# MEMO

**TO:** David Usmar **DATE:** 18<sup>th</sup> November, 2022  
**FROM:** Sejal Sangwai **PROJECT NO.:** J000663  
**REVIEWE:** James Taylor  
**SUBJECT:** Initial Review of Stormwater Management for Private Plan Change 81

Figure 1: Extracts from Awa's Dargaville Urban Stormwater Model

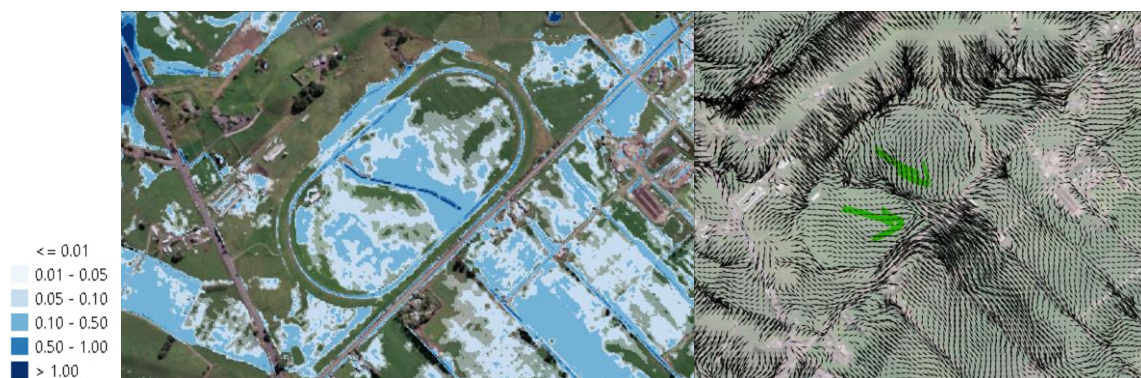
Awa has also used the preliminary Dargaville Urban Stormwater Hydraulic Model, currently being built by Awa for KDC to check the potential flooding impacts on the site. The model currently only contains a 2D domain, with 1D pipe networks still to be added. It is noted that there are presently few/no pipe networks in this area, therefore the predicted flooding in this is unlikely to substantially change as the model is further developed.

The model shows that the existing site is subject to substantial ponding in the 100-year ARI event, as it is low-lying and is effectively bounded by Awakino Point Road. It will be necessary for any development to displace or drain this flooding in order to create safe building platforms, which could have an adverse impact on downstream flooding if not adequately mitigated.

The application provides no discussion as to how this low-lying ponding will be managed.
